# Submission on the Environmental Impact Statement for Sydney Metro West

This submission focuses on the Sydney Metro West station in Westmead (“Westmead Metro Station”) and the Sydney Metro West alignment in Westmead. The submission considers interchanges at Westmead between Sydney Metro West trains and other public and private transport modes, including Parramatta Light Rail trams and buses.

The figure to the right is a modification of Figure 3-1 in the EIS (see “Chapter 3 - Sydney Metro West development and alternatives”, p3-4). The yellow dotted rectangles show the three Westmead metro station location options:

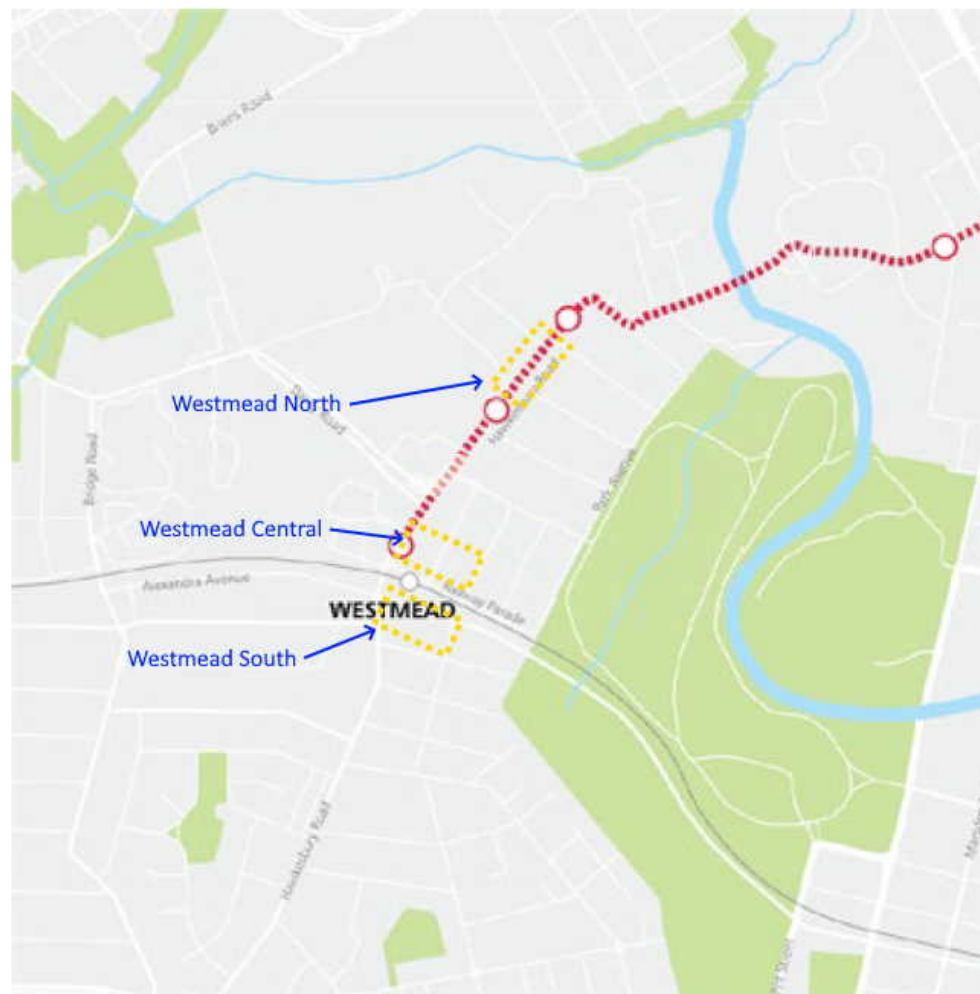
There should be no confusion between the metro station location advocated by this submission – namely, a location immediately to the north of Westmead Railway Station – and the “Westmead North” location evaluated in the EIS (see “Chapter 3 - Sydney Metro West development and alternatives”, p3-4, Table 3-3), which is located towards the northern end of Hawkesbury Road.

- Option 1. **Westmead North**, presumably having a north-south orientation, adjacent to Westmead Hospital and The Children's Hospital at Westmead. This option is rejected in the EIS.
- Option 2. **Westmead South**, with an east-west orientation, immediately to the south of Westmead Railway Station. This option is presented as the preferred option in the EIS.
- Option 3. **Westmead Central**, with an east-west orientation, immediately to the north of Westmead Railway Station. This option is advocated by this submission. *Inexplicably, this option was not even considered in the Environmental Impact Statement.*

*Although the proposals I submitted to Sydney Metro have clearly advocated a Westmead Central station location, not a single mention of this option appears in the EIS.*

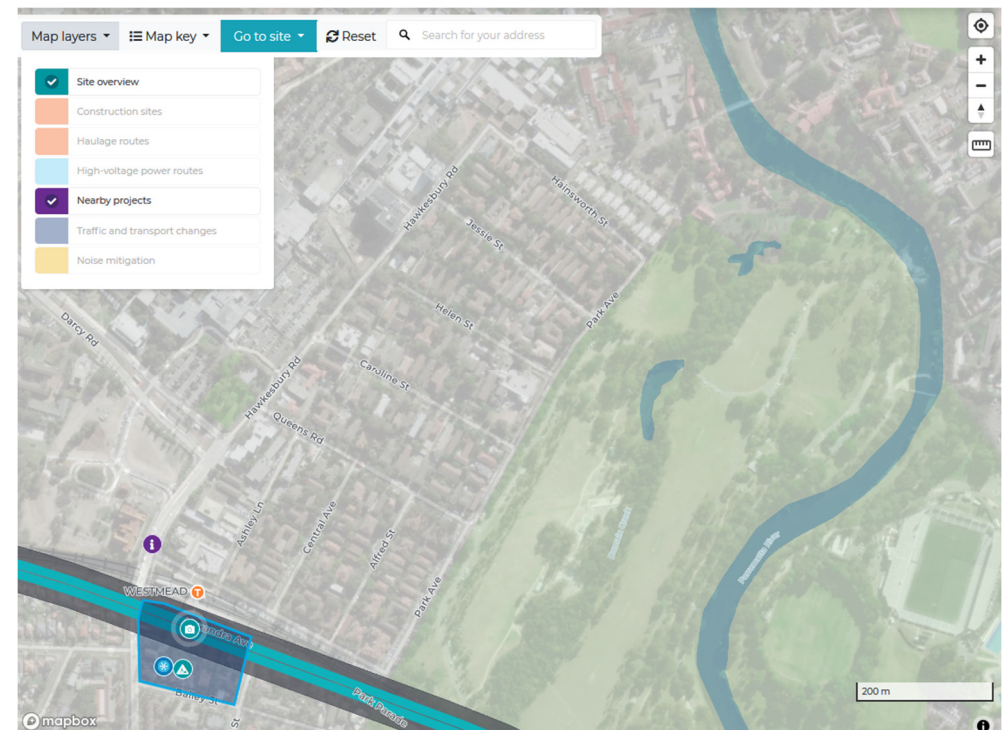
As I have argued in this submission, the Westmead South station location does not provide the best possible interchange between Sydney Metro West and Parramatta Light Rail. This would be more obvious if the Parramatta Light Rail alignment and stops were actually shown (perhaps as a selectable layer) on the interactive portal.

However, the Parramatta Light Rail alignment and stops in Westmead are *not shown* in the interactive portal. A screen capture of the portal, at right, shows this. It also shows that PLR is not available as a map layer. An "i" icon can be shown indicating "nearby projects", which when clicked, provides a link to the PLR web site. Users of the interactive portal would need to proactively select this layer, click on the "i" icon and then conduct their own research to of the PLR web site just to see where the PLR alignment and stops would be on this map. Not many people will do this. The result is that contributors to the EIS are thus effectively denied relevant information.

Even more mystifying is the fact that PLR alignment and stops on the old Carlingford railway line *are shown* on the interactive portal. The implication is that some parts of the PLR alignment and some of the PLR stops are relevant (i.e., Camellia to Carlingford), but others are not relevant (including in Westmead). This makes no sense.

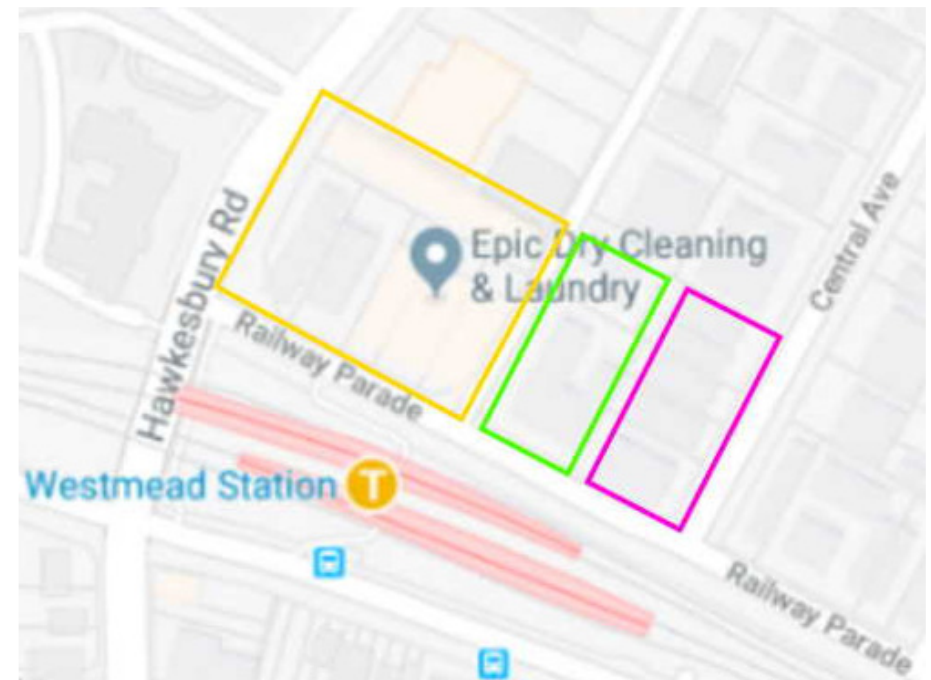
The proposed building/structure at this Westmead Central location (Westmead Grand Central) would comprise Site A, and optionally (for demolition/excavation purposes only, or for the final Westmead Grand Central building/structure) Site B and, if even more space is required, Site C. (The sites are illustrated in the appendix to this submission – see file “Proposal for Westmead Grand Central - Appendix to EIS submission by Peter Mendes-Shineberg 20200612”.) The sites are defined as follows (see at right):

- **Site A (yellow outline):** The area bounded by Hawkesbury Road, Railway Parade, and Ashley Lane, up to and including 149 Hawkesbury Road on the northern side. (Only 2 properties stand on this site.)
- **Site B (green outline):** If the eastern boundary of Site A needs to extend beyond Ashley Lane: 21-23 Railway Parade and 16 Ashley Lane.
- **Site C (pink outline):** If the eastern boundary of Site B needs to extend all the way to Central Avenue: 16 Railway Parade and 6, 8 and 12 Central Avenue.
